# Audio Amateur Corporation

## NOTICE OF DISCREPANCIES ON THE PASS A-40 AMPLIFIER PCB

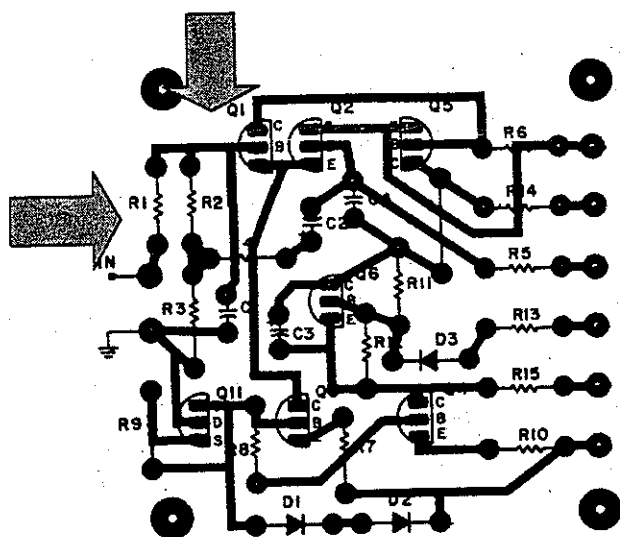
The printed circuit board called PASS A-40 has been found with a trace error on the base of Q1. The following graphics depict the differences between the board as it should have been reproduced and the way in which it actually was made. By cutting ONE trace and soldering a single jumper wire, the problem can be resolved.

Depicts the way the board is upon receipt

Depicts the board after corrections
